From: [REDACTED]
To: [Norfolk Vanguard](#)
Subject: Norfolk Vanguard Project 010079.
Date: 23 March 2020 21:31:10
Attachments: [viewpoint3landform2.png](#)
[viewpoint7landform2.png](#)

Viewpoint 3. Scenario1. Landform Cross-Section + Converter Hall, and View Line Positioned In Scale.

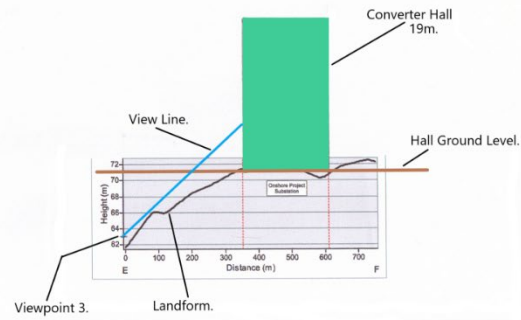
I would like to comment on some of the applicants answers to the ExA's written questions. 2.9.3.3. I found the cross-sections of the land form provided by the applicant of little use. I have taken the cross- section diagrams and added a 19m converter hall, a level ground, line of view, a viewpoint at 1.5m, and mitigating trees where applicable, using the appropriate scales. This again shows a discrepancy when compared to the photo montages. After completing the diagrams, which again appeared different to what I expected, I realised they are not drawn to scale. The applicant used one rate of scale for distance, and another for the height. The result is a diagram compressed in length, and overly high. This makes the line of view falsely steep, and the point it intersects the hall unrealistically high. If the diagram had been prepared in scale, it would be much longer, the line of view much shallower, and most of the converter hall would be visible, as I have always suspected.
